Project	<b>IEEE 802.16 Broadband Wireless Access Working Group</b> < <a href="http://ieee802.org/16">http://ieee802.org/16</a> >	
Title	<b>Comment on Sub-Channel Reuse for CQICH Fast Feedback Channels</b>	
Date Submitted	<b>2004-11-14</b>	
Source:	Mohammad Ali Maddah_Ali, Mahmoud Taherzadeh, Amir Khandani, Wen Tong, Jianglei Ma, Peiyong Zhu, Ming Jia, Dongsheng Yu, Hua Xu, Mo-Han Fong, Hang Zhang, Brian Johnson	Voice: (613)-763-1315 Fax: (613)-765-7723 <a href="mailto:wentong@nortelnetworks.com">wentong@nortelnetworks.com</a>
	Nortel Networks 3500 Carling Avenue Ottawa, ON. K2H 8E9 CANADA	
Re:	Response to Sponsor Ballot call for comment	
Abstract	To improve the CQICH Fast Feedback Channels. <a href="#">The update is in blue font.</a>	
Purpose	Comment on Sub-Channel Reuse for CQICH Fast Feedback Channels	
Notice	This document has been prepared to assist IEEE 802.16. It is offered as a basis for discussion and is not binding on the contributing individual(s) or organization(s). The material in this document is subject to change in form and content after further study. The contributor(s) reserve(s) the right to add, amend or withdraw material contained herein.

# Comment on Sub-Channe

Figure 1 Performance enhancement of 4/5/6 bits CQICH channels

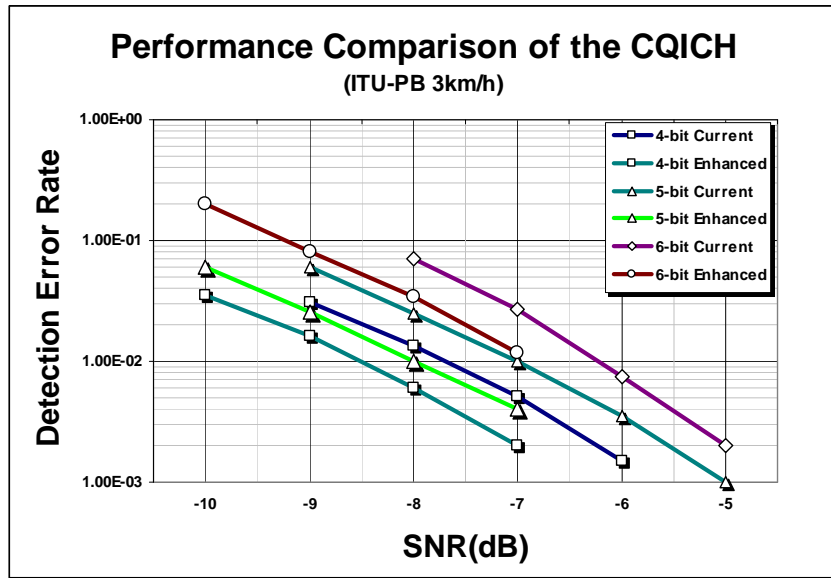
Figure 1 and Figure 2 present the simulation results, as we can see the enhanced CQICH has a coding gain of 1dB and for 2x2 STC coded CQICH has a 2dB gain. This benefit can be translated into performance improvement when the sub-channel reuse is employed or can be translated into battery life enhancement.
